# Service Bulletin

Bulletin No.: PI1353

**Subject:** Information on Incorrect Service Part Number on ECM Label

4010219

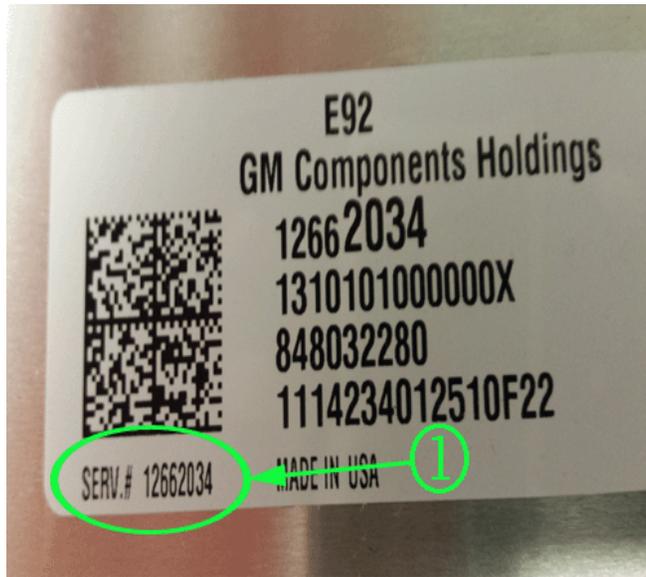
The purpose of this bulletin is to inform dealers that the E92 Engine Control Module (ECM) labels have an incorrect service part number.

The incorrect service part number 12656993 as shown above for a E92 (1) label is for the 2014 model year vehicles. DO NOT use for 2015 model year vehicles.

The correct service number is 12662034 (1) as shown above. Use this service part number for 2015 model year vehicles.
